TILLMAN'S SQUARE SUBDIVISION, RESUBDIVISION OF LOT 1

APPLICATION NUMBER 12 DATE September 4, 2008

REQUEST Subdivision

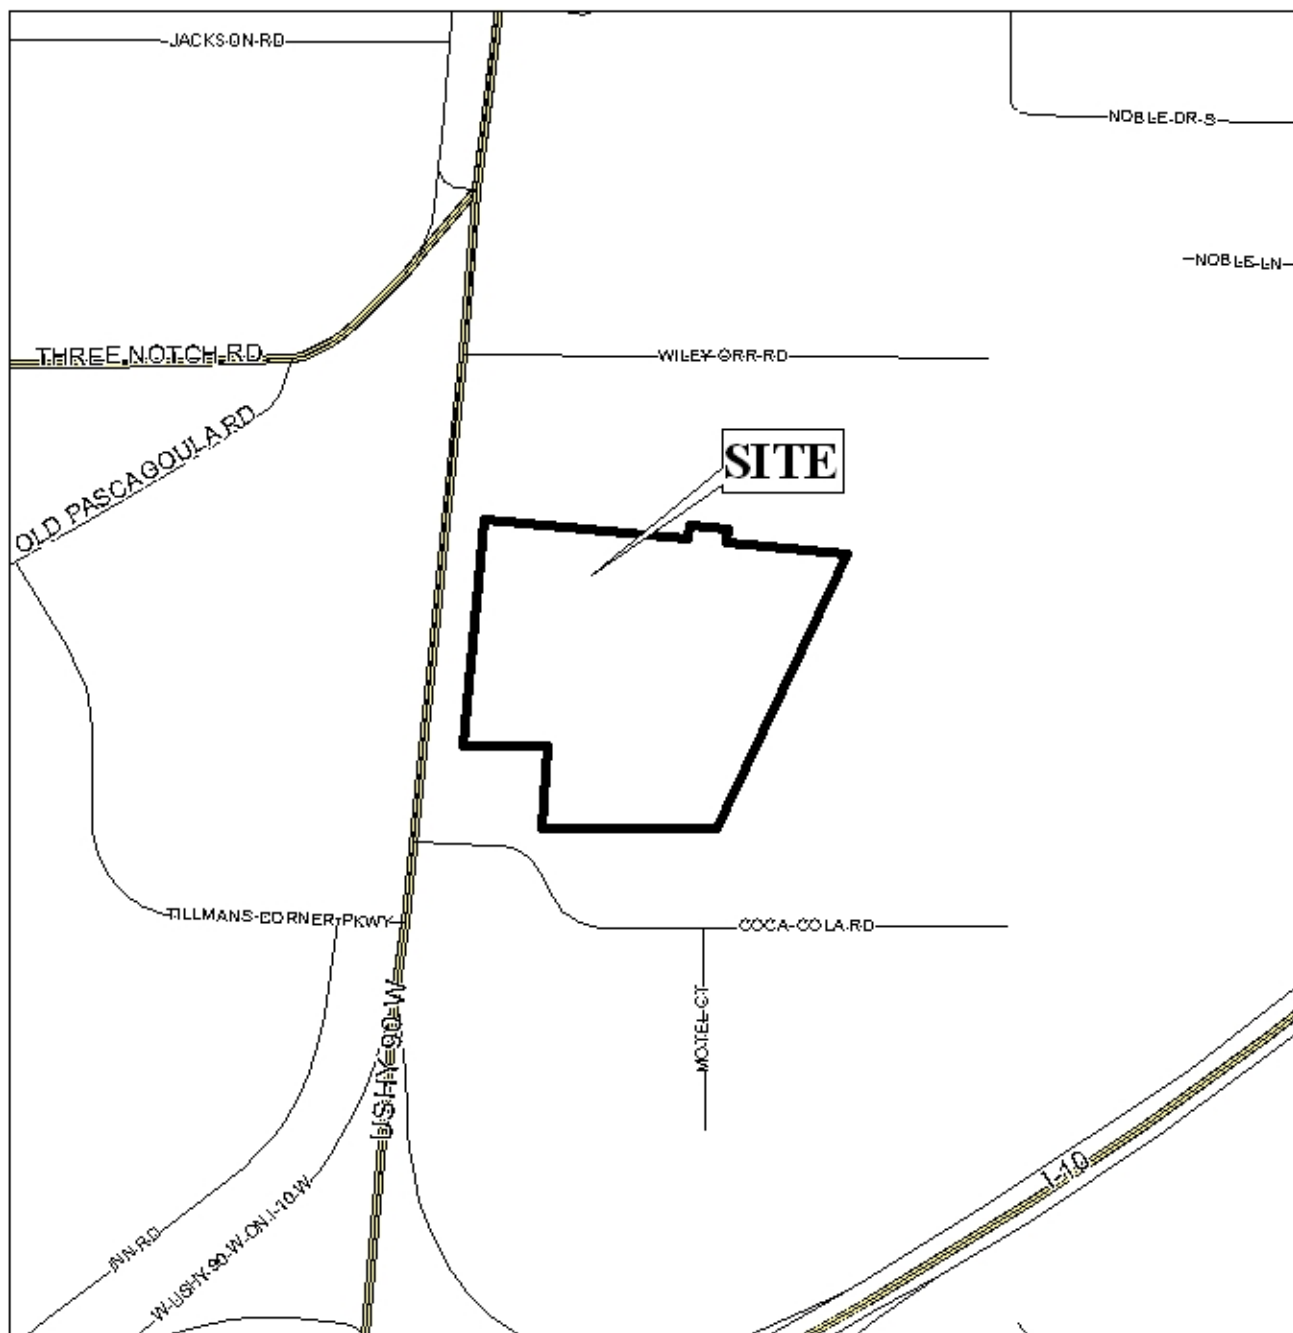
As originally submitted with this application, the plat indicated Lot 2 would be totally landlocked. A revised plat was encouraged of the applicant to correct the situation, and the current proposed configuration was presented. Another revision was encouraged which would eliminate the "pole" access and extend the North and South property lines to the existing U.S. Highway 90 West right-of-way line allowing total width street frontage, but such was rejected by the applicant.

As proposed, Lot 2 would have the minimum 25' of street frontage and would be at least 60' wide at the building setback line. However, due to its irregular shape, it would not meet the requirements of Section V.D.1. of the Subdivision Regulations, as amended in April 2008 to prohibit such lots. Allowances are made for such lots to be approved in areas where similar lots are common and the informality of design is consistent with other lots in the vicinity. Requests for panhandle lots must be accompanied by evidence showing that each panhandle lot is necessary to allow the site owner reasonable use of the site or to alleviate a situation that would otherwise cause extreme hardship. As proposed, Lot 2 is not consistent with other lots in the vicinity, and no evidence was submitted which demonstrated the necessity of the configuration to alleviate a situation which would otherwise cause extreme hardship.

- 1) Lot 2 would not be consistent with the shape of other lots in the vicinity; and
- 2) No evidence was submitted which demonstrated the necessity of the configuration to alleviate a situation which would otherwise cause extreme hardship.
